## APPLICATION FOR MODIFICATION ASSESSMENT REPORT

<b>Application Number:</b>	Mod2019/0499
----------------------------	--------------

<b>Responsible Officer:</b>	Renee Ezzy
<b>Land to be developed (Address):</b>	Lot CP SP 10040, 46 Victoria Parade MANLY NSW 2095
<b>Proposed Development:</b>	Modification of Development Consent No. DA367/2010 granted for demolition of an existing building and construction of a 7 storey Residential Flat Building containing 11 units with 2 levels of basement carparking and associated decks and landscaping
<b>Zoning:</b>	Manly LEP2013 - Land zoned R3 Medium Density Residential
<b>Development Permissible:</b>	Yes
<b>Existing Use Rights:</b>	No
<b>Consent Authority:</b>	Northern Beaches Council
<b>Delegation Level:</b>	NBLPP
<b>Land and Environment Court Action:</b>	No
<b>Owner:</b>	Proprietors of Strata Plan 10040
<b>Applicant:</b>	Mod Urban Pty Ltd

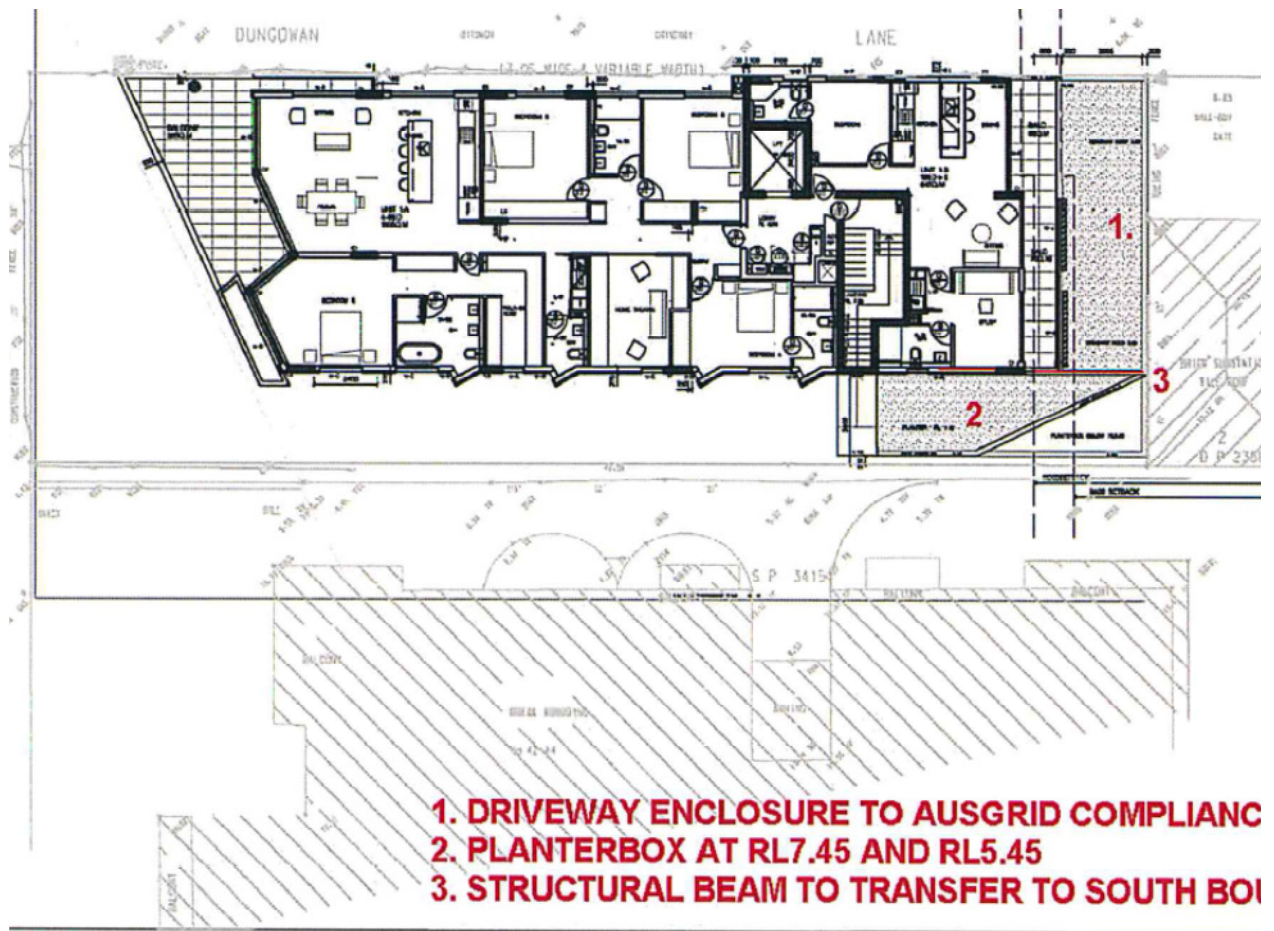
**Current Condition 97**

*The level at the top of the headlight cut-off wall adjoining the driveway shall be RL7.450. Plans being suitably notated prior to the issue of the CC.*

*The structural wall to a height of RL7.450 as shown on the approved plan 2424-A103 rev A shall be maintained to minimise impacts from headlight glare to the adjoining residential properties.*

The submissions received state that the new drawing No. 2424-A203 8 "West Elevation" supplied with this application now shows there is to be a planter box put on top of this RL 7.45 which is not in the condition.

As this item has not been identified as a formal change to the plan and no detail has been provided to inform what this might look like or potential impacts, the change to this condition cannot be supported. It is recommended that this condition be retained as imposed.

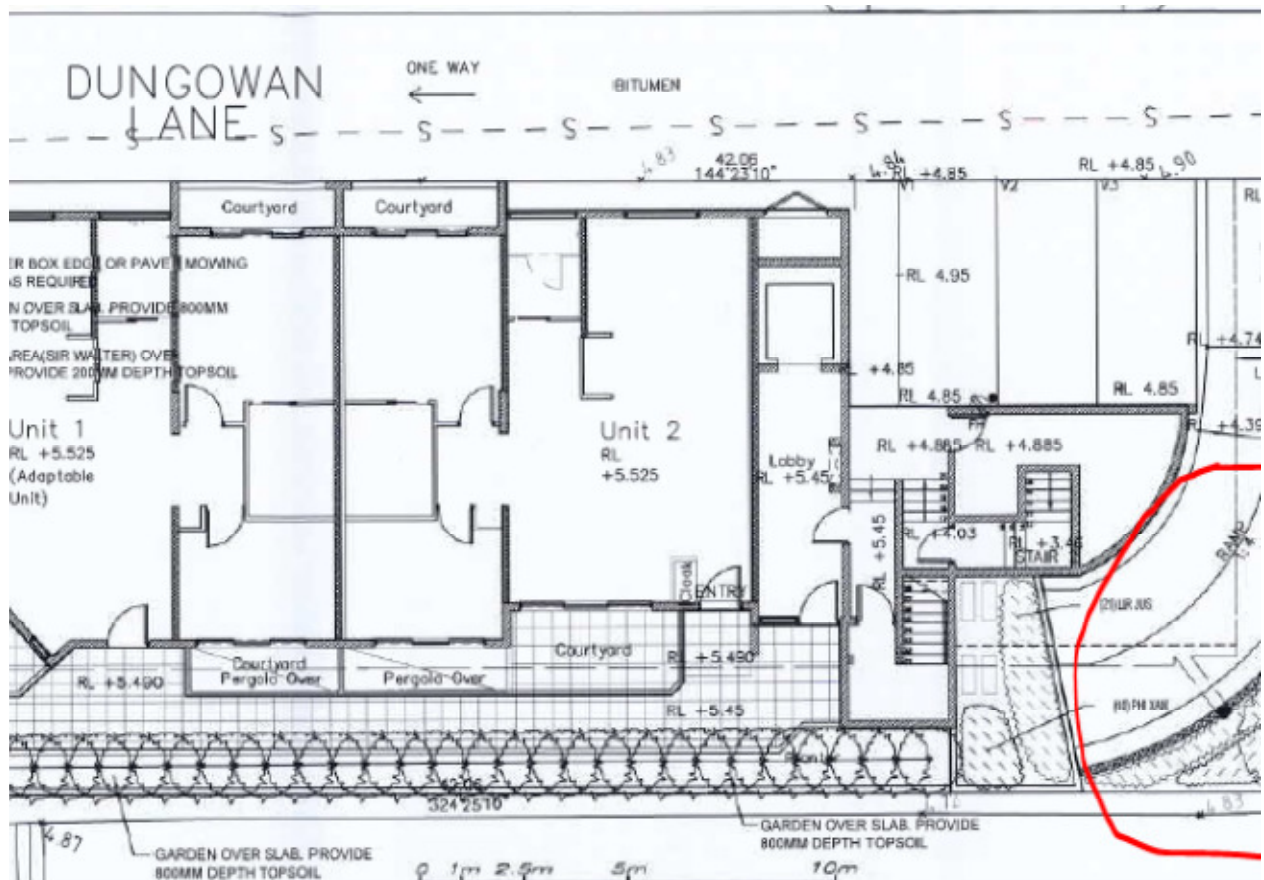
In relation to the issues raised with this condition, the plans submitted provide the following reference to a new planter **"2. Planterbox at RL 7.45 and RL 5.45"**

Planting in the south-west corner of the site at RL 5.45 was previously approved as part of the Court's Consent and modified in 2014 (Drawing No 1304-LP1 - Landscape Plan-Ground Level Issue G dated January 2014). See part plan below referencing planting in that location.

The residents submission in relation to this element, claims that anything in this location that adds additional height would be in complete view of their apartment and would create more visual bulk and block airflow.
